MILITARY SPECIFICATION

MODULES, STANDARD ELECTRONIC

RELAY, LATCHING, KEY CODE MFD

MIL-M-28787/343(EC)
AMENDMENT 2

FIGURE 3. Component temperature and life test circuit.

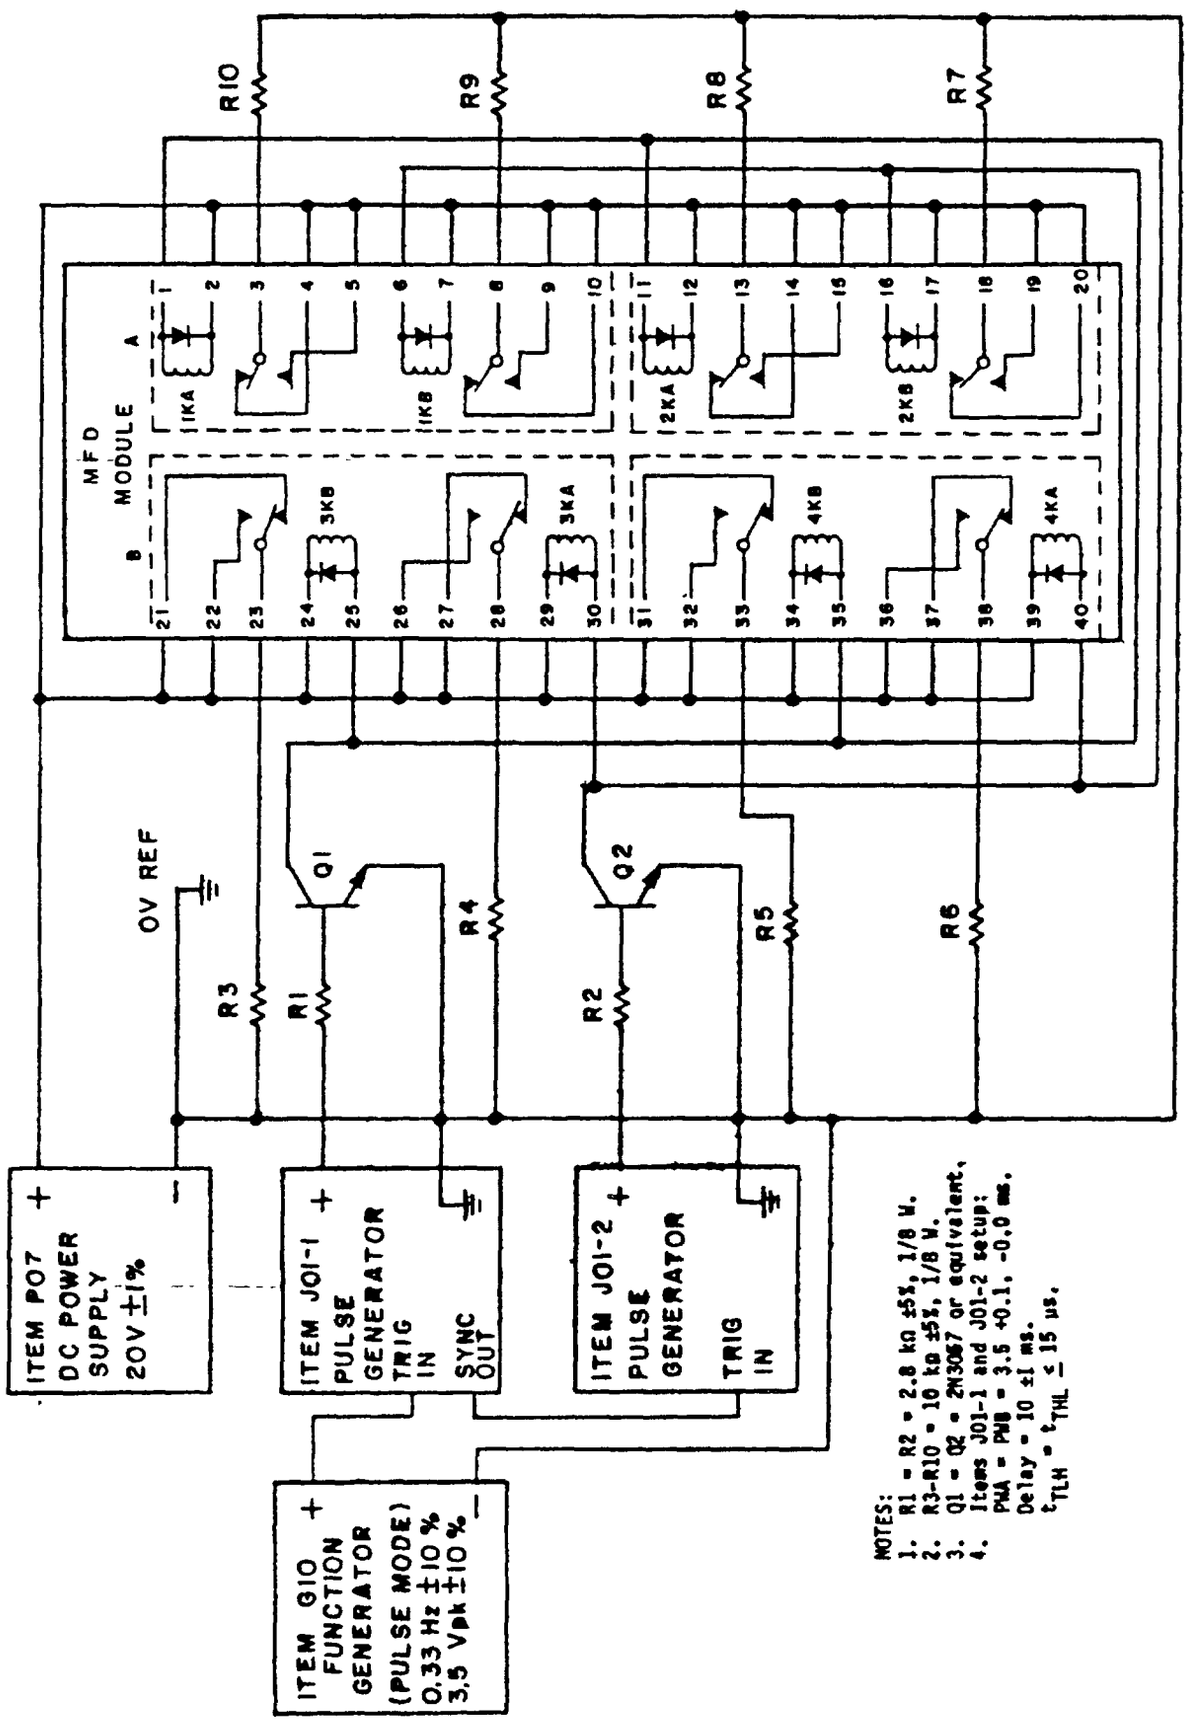
4.5.3, second sentence: Delete and substitute "The module shall be operated for 100 000 operations as shown on figure 3."

FIGURE 3: Delete and substitute new figure 3 as printed on page 2 of this amendment.

FIGURE 5. Resistance (open contact) test circuit for table III.

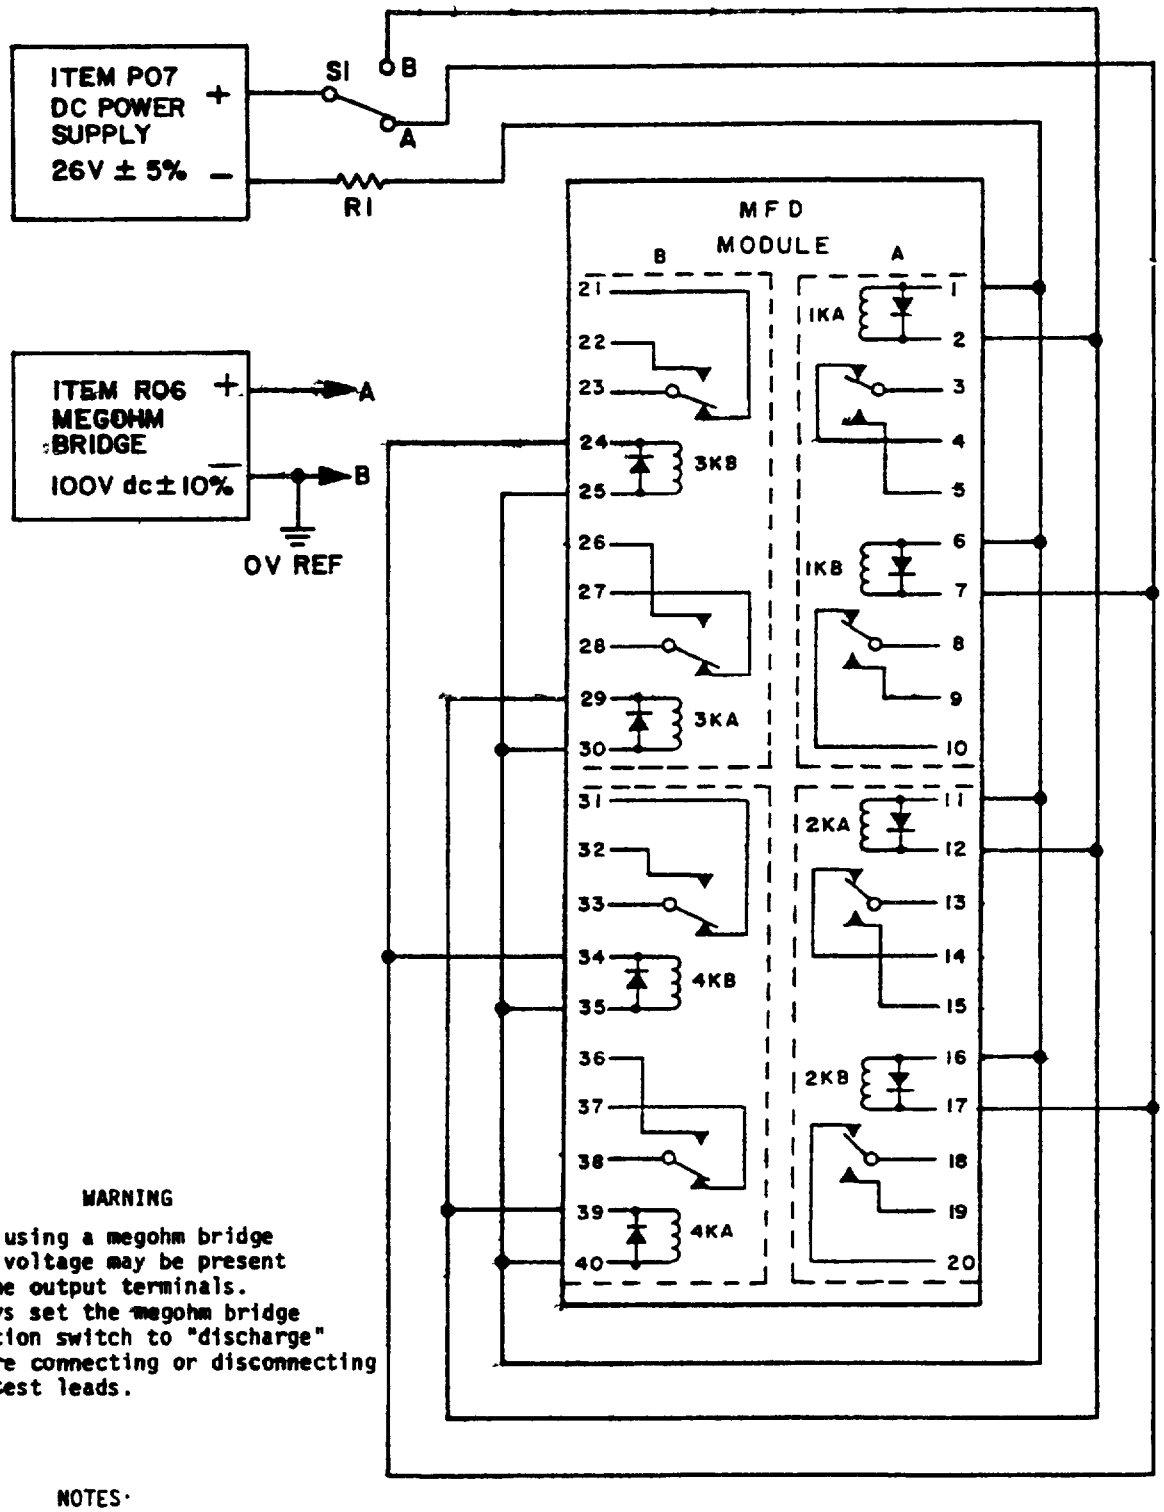
* FIGURE 5: Delete and substitute new figure 5 as printed on page 3 of this amendment.

FIGURE 6. Resistance (closed contact) check test circuit for table IV.

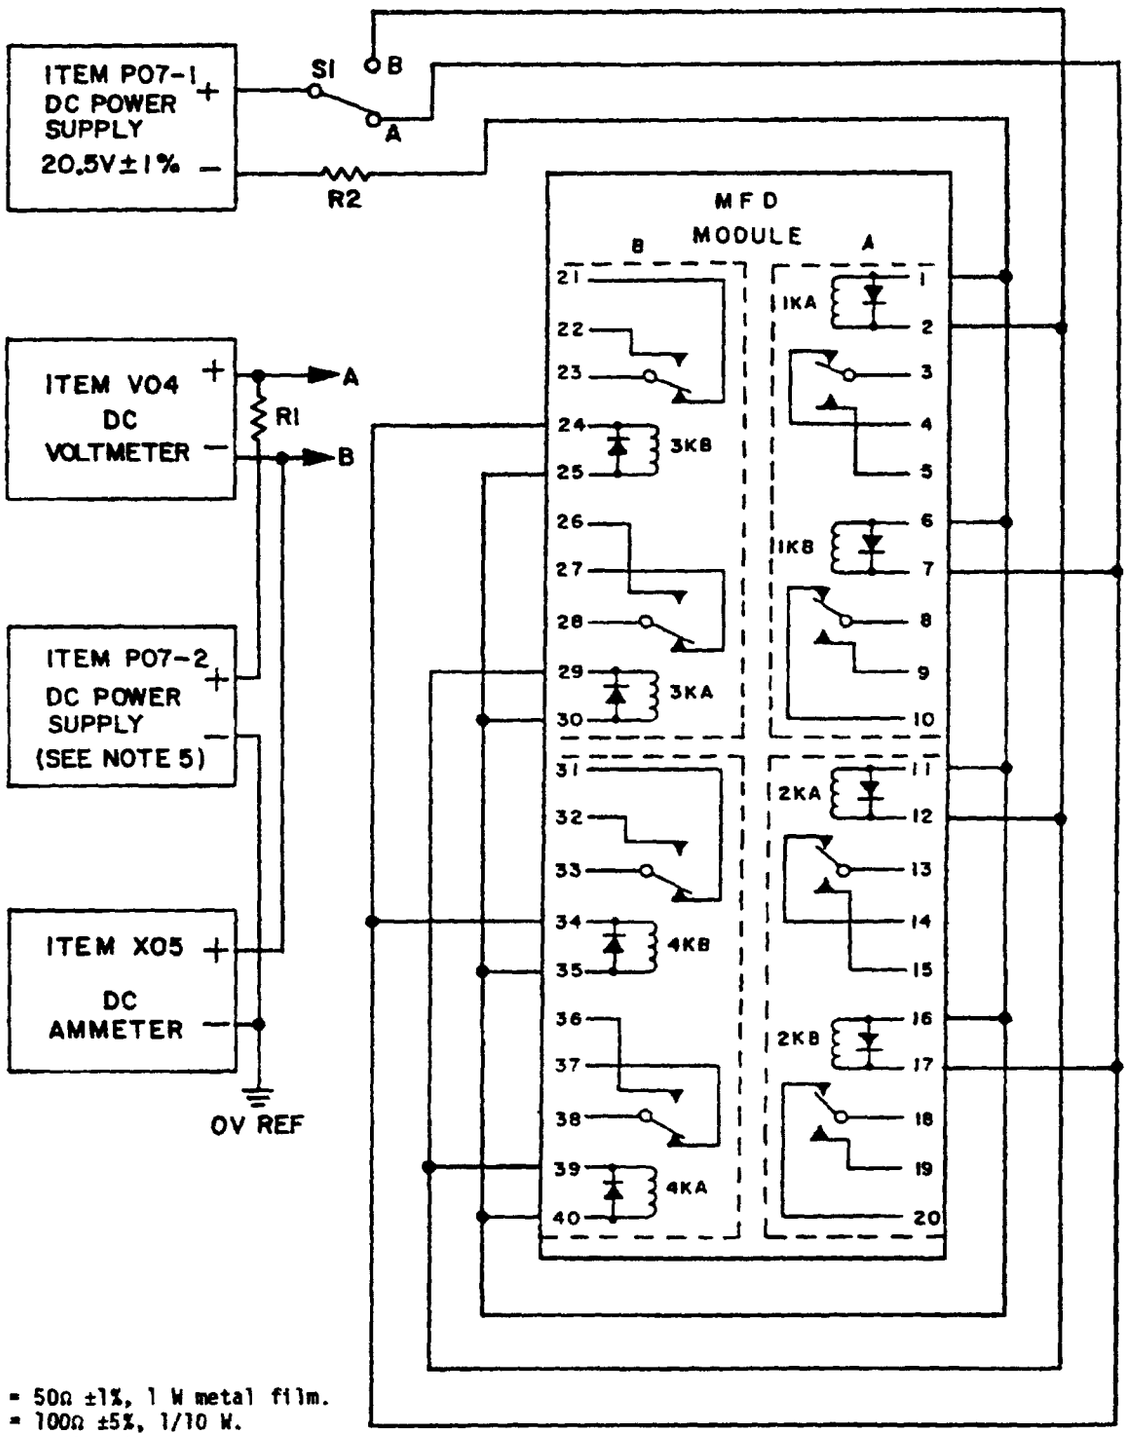
* FIGURE 6: Delete and substitute new figure 6 as printed on page 4 of this amendment.

FIGURE 11. Operate time and contact bounce test circuit waveforms for tables XIII and IX.

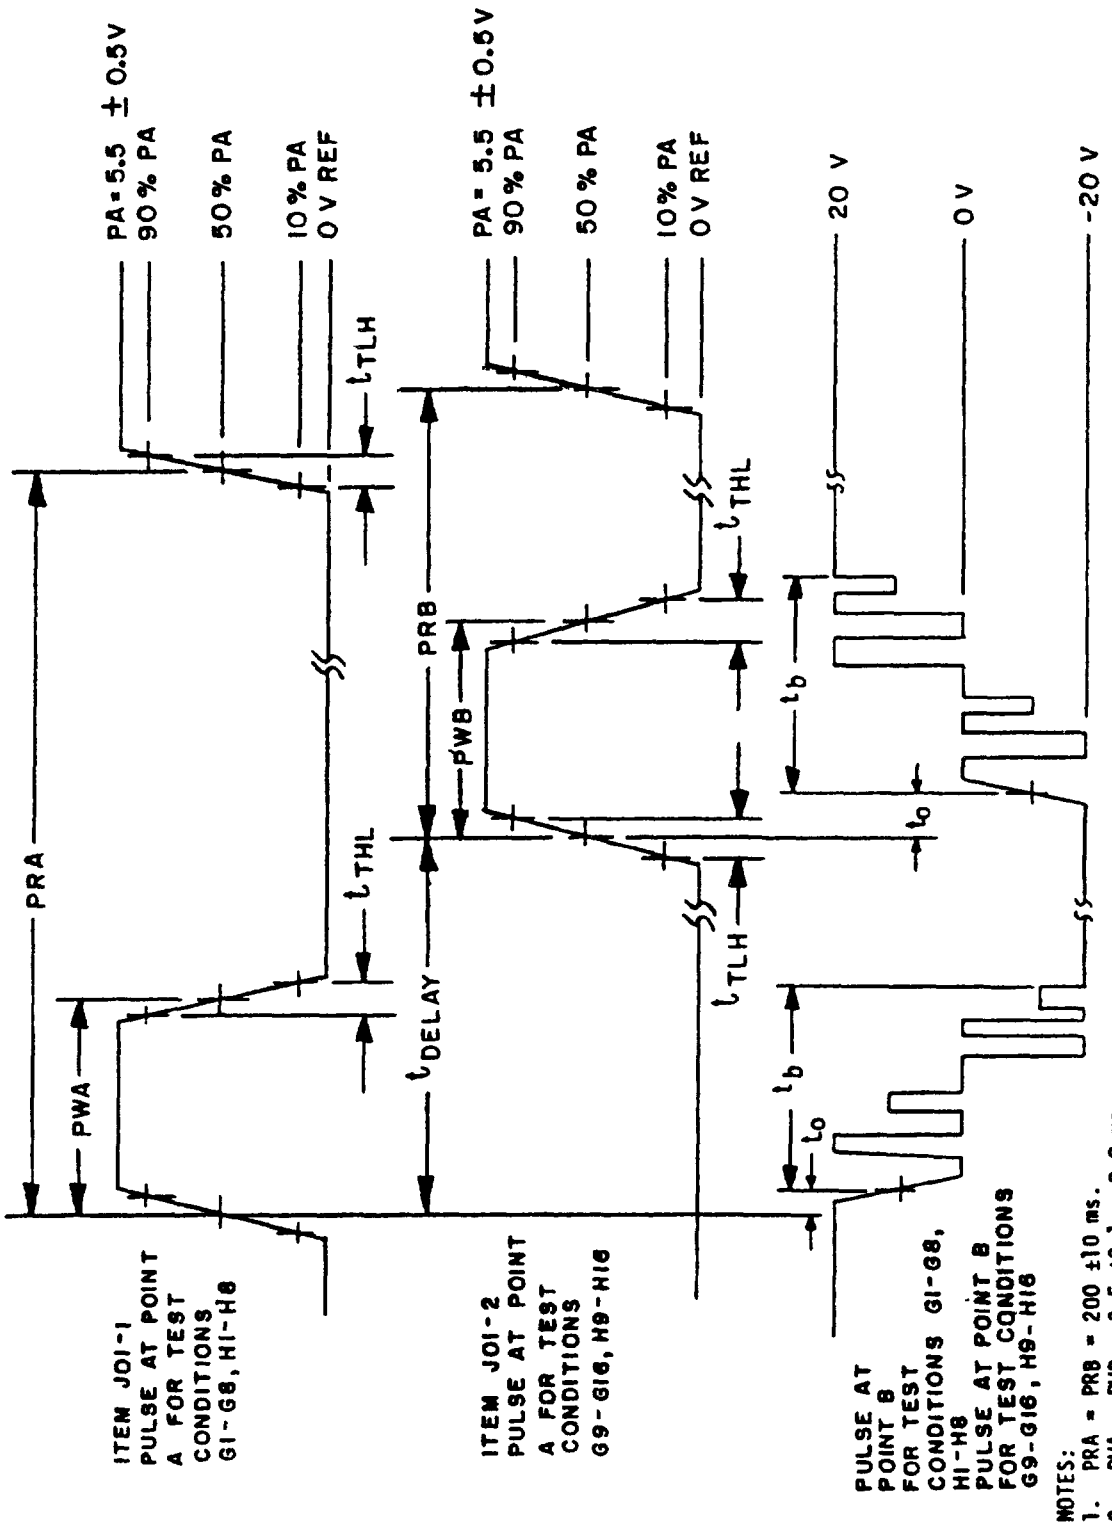
FIGURE 11: Delete and substitute new figure 11 as printed on page 5 of this amendment.
